ADDENDUM NO. 3

COMMUNITY PARK ELEMENTARY SCHOOL

Issued: January 30, 2026

FVHD PROJECT NO. 5516C

A002

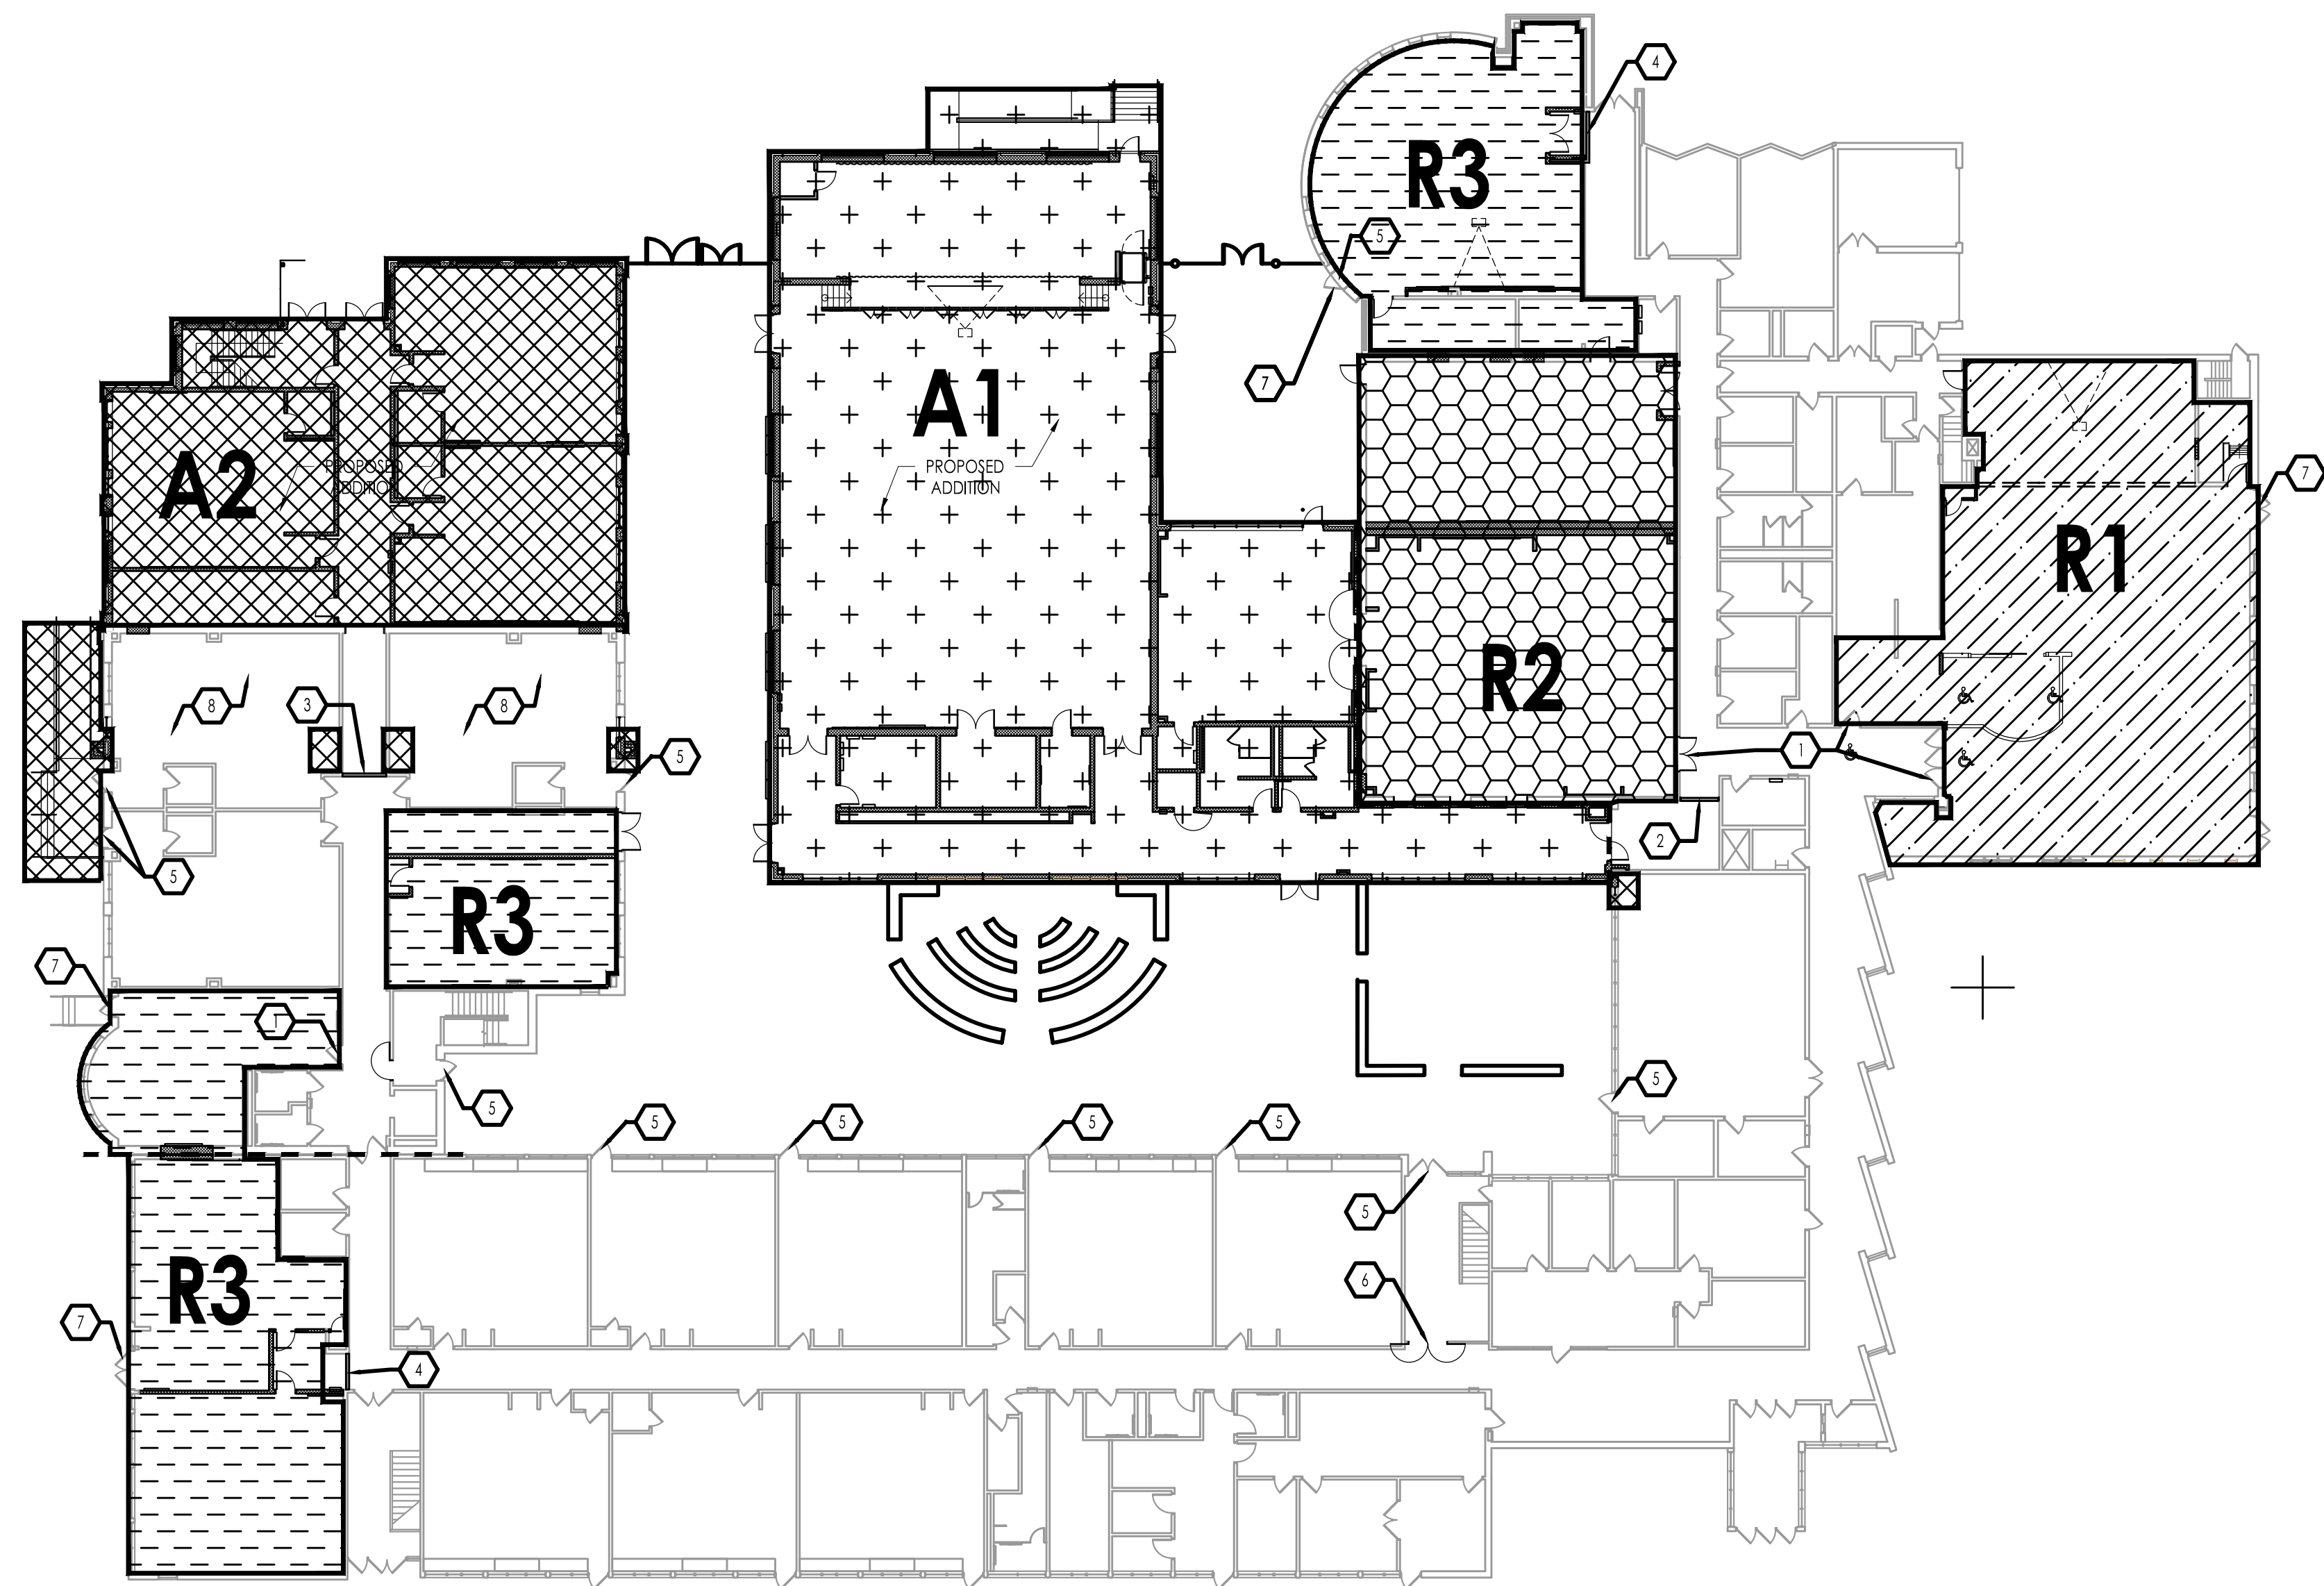
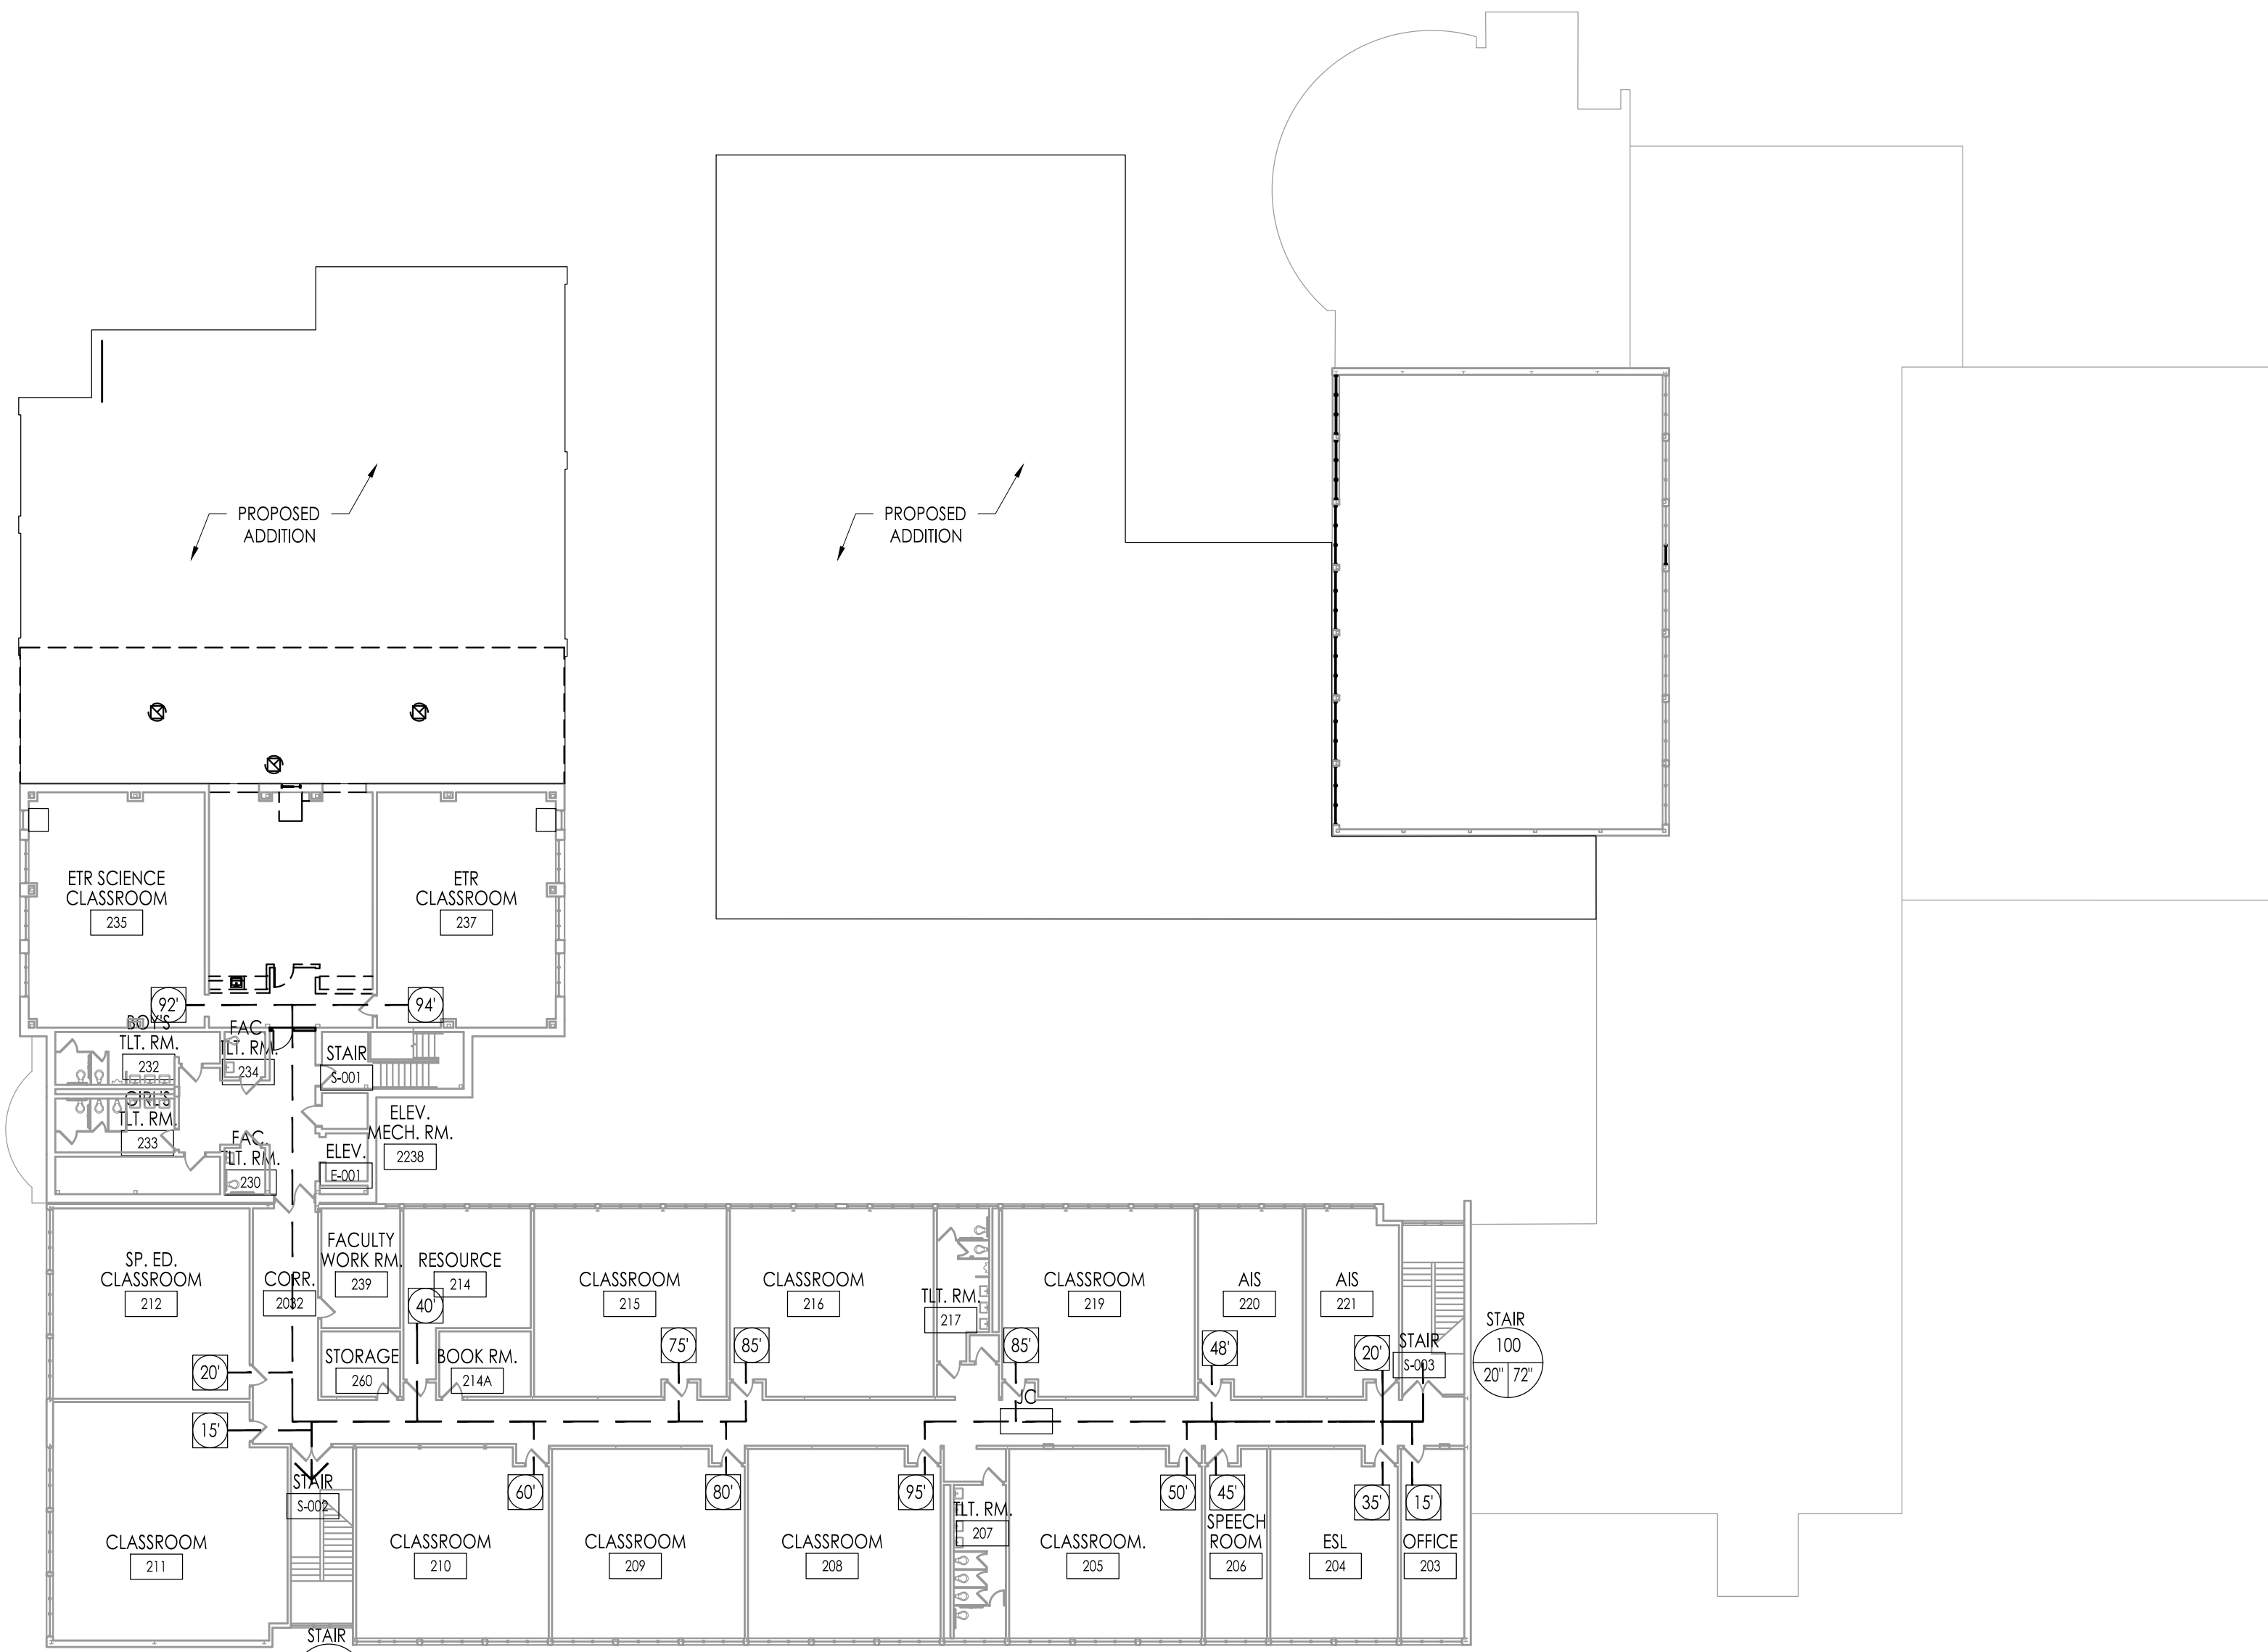
- CHANGE DOOR TO SWING OUT OF STAIR AND INTO HALLWAY. HINGE TO ALLOW FOR 180° SWING FOR COMPLIANCE WITH 2021 IBC NJ EDITION 1005.7.1.
- TEMPORARY CONSTRUCTION ENTRANCE. CONTRACTOR TO COORDINATE WITH OWNER AND CONSTRUCTION MANAGER FOR PERSONAL ACCESS.
